Project	<b>IEEE 802.16 Broadband Wireless Access Working Group</b> < <a href="http://ieee802.org/16">http://ieee802.org/16</a> >
Title	<b>Stuff, the sequel</b>
Date Submitted	<b>2002-10-21</b>
Source(s)	<a href="#">Nico van Waes</a> <a href="#">Nokia Wireless Routers</a>
Re:	IEEE LMSC Sponsor Ballot recirculation of P802.16a/D5
Abstract	Proposed material referenced by submitted comments.
Purpose	Adoption
Notice	This document has been prepared to assist IEEE 802.16. It is offered as a basis for discussion and is not binding on the contributing individual(s) or organization(s). The material in this document is subject to change in form and content after further study. The contributor(s) reserve(s) the right to add, amend or withdraw material contained herein.
Release	The contributor grants a free, irrevocable license to the IEEE to incorporate material contained in this contribution, and any modifications thereof, in the creation of an IEEE Standards publication; to copyright in the IEEE's name any IEEE Standards publication even though it may include portions of this contribution; and at the IEEE's sole discretion to permit others to reproduce in whole or in part the resulting IEEE

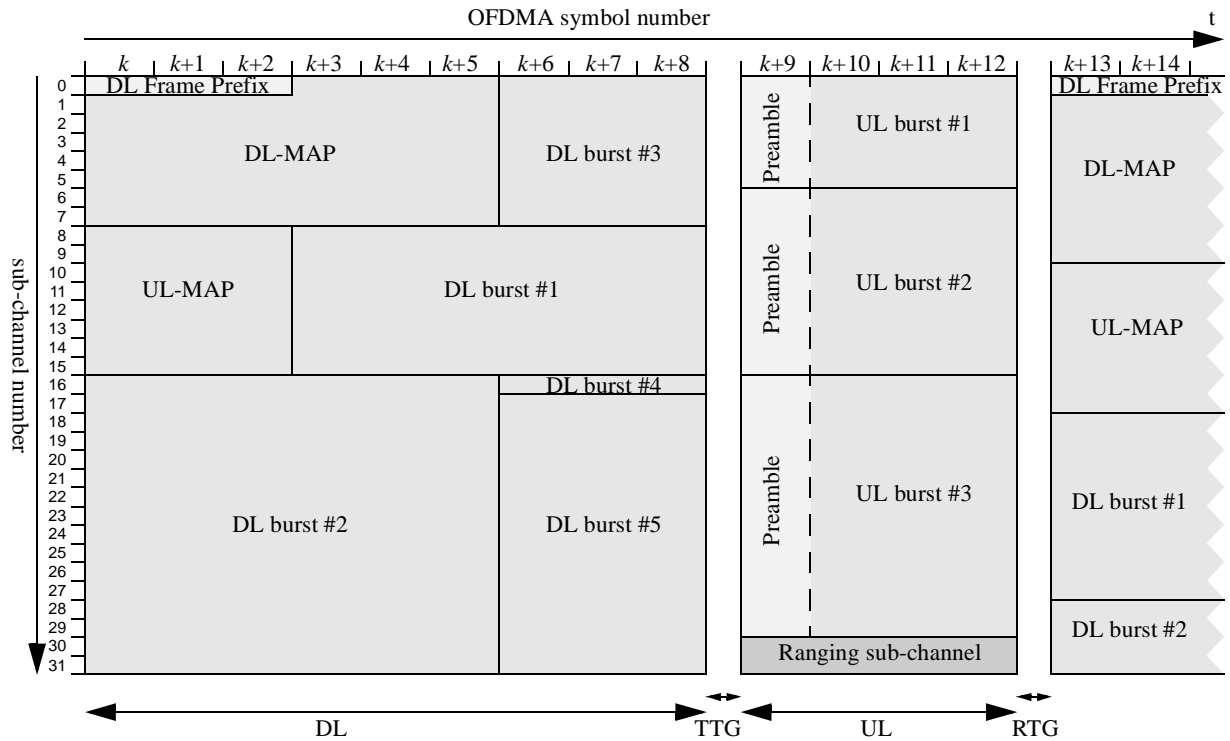
*Replace Figure 128ax with:*
